STORMWATER MANAGEMENT PLAN REVIEW

Western Freeway Commercial Area – Urban Design
Framework

Date 1 October 2026

Project No. 24184

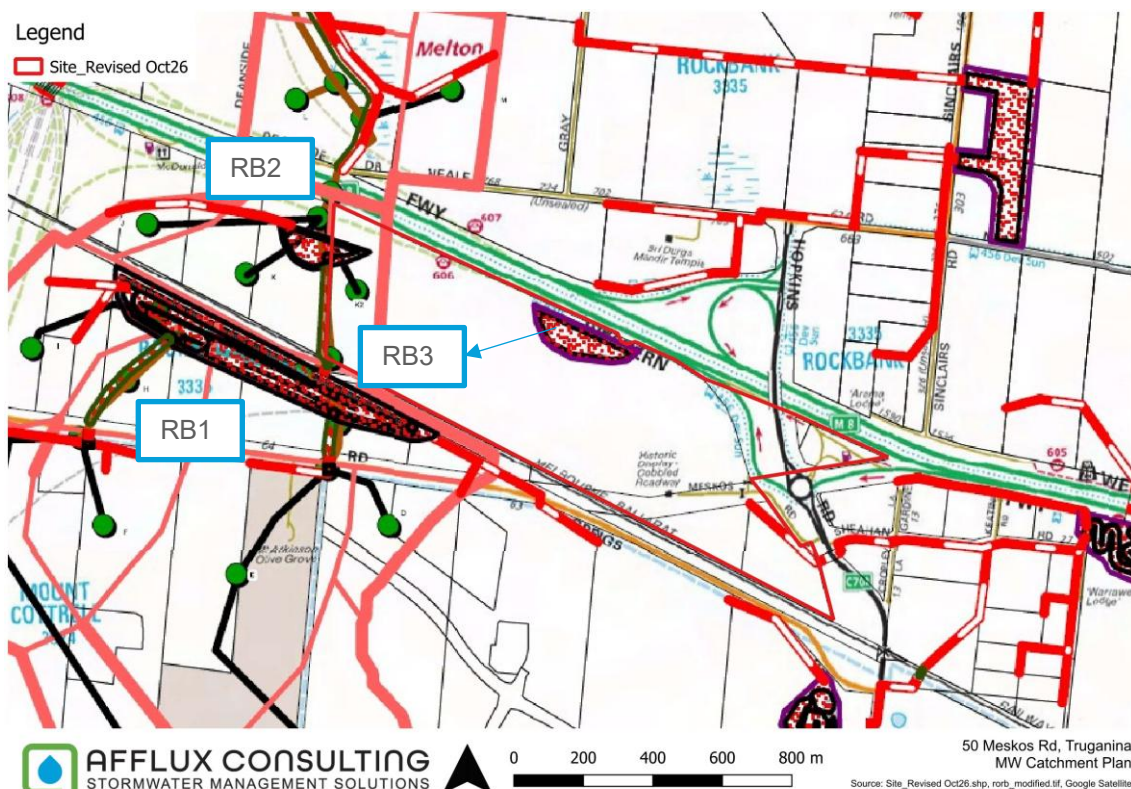
The preliminary Gardiner Lane DSS - 4177 - (Figure 3) indicates that the ultimate drainage discharge location for this site involves construction of RB3 at approximately the centre of the northern boundary of the site. This will provide attenuation of the flows originating from this site prior to discharge into the pipe networks across Western Fwy ultimately to Kororoit Creek.

Due to the reasons below, this approach is not practical and has inherent risk:

- The current discharge location is via a set of culverts (to be constructed) into a pipe system to the Wetland/RB along Sinclairs Rd. In the event of a catastrophic failure or an extreme storm event these flows would need to be conveyed through public streets to Kororoit Creek. Realigning this outlet into the Deanside Drive DSS would facilitate a lower risk by conveying these flows via a waterway rather than through the road network.
- Construction of culvert crossings on a freeway will cost significant time and resources. Additional culverts are currently proposed to be constructed under the Western Freeway from Deanside Drive DSS (4169). This would consolidate the number of crossings and reduce the impact on the local community due to this construction disruption.

As an alternative, the following is suggested for consideration:

- Realign this catchment outlet into the Deanside Drive DSS
- Relocate RB3 to the south-western corner of the site – subject to functional design

Figure 12. Proposed WLRB3 location

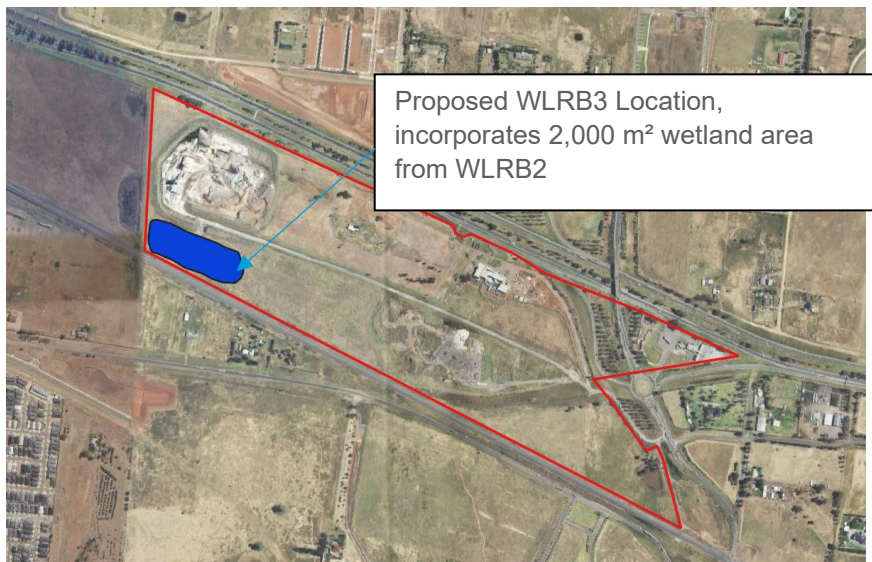
As discussed in the previous sections, relocation of WLRB3 must be considered. Generally, it is recommended to position wetlands and/or retarding basins near the proposed site outlet. In this case, it would be the northwest corner of the site. However, it is understood that a concrete plant currently exists at the recommended location, and it is expected to remain there for a significant period. Figure 11 shows the proposed asset location. Figure 12 shows the long-section for the existing terrain.

Figure 14. Proposed Draft PSP amendment

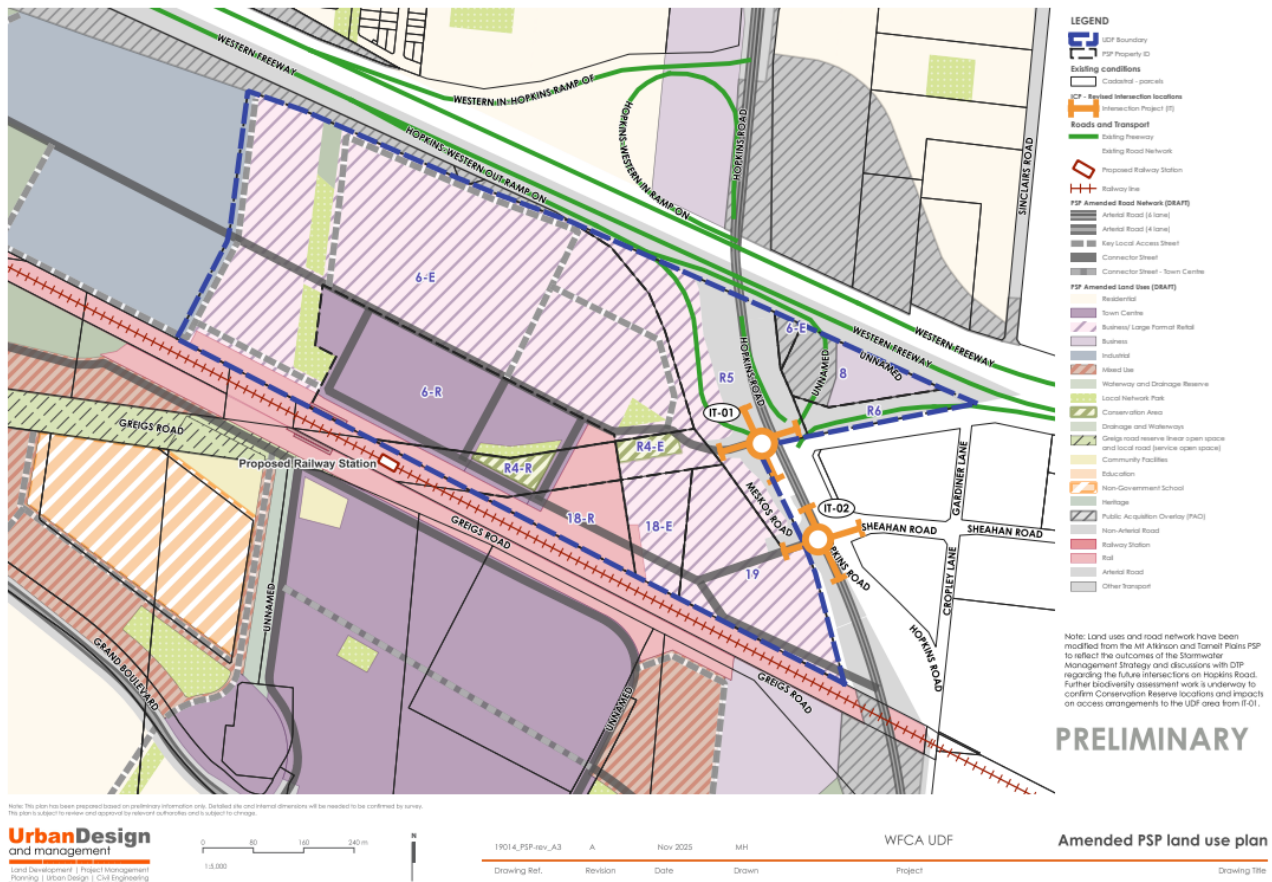
Consequently, this implies that an amendment of the PSP should be undertaken, particularly the alignment of the drainage reserve along the site. Figure 13 shows the proposed amendment from UDM.

- Begin consultation with Council and Melbourne Water to realign both the DSS and confirm the changes are generally in accordance with the PSP. There is no overall land use change, just a rearrangement of land uses within parcels.
- Update the two DSS's to reflect the realignment of ultimate discharge from the 50 Meskos Site via the Deanside Drive DSS.
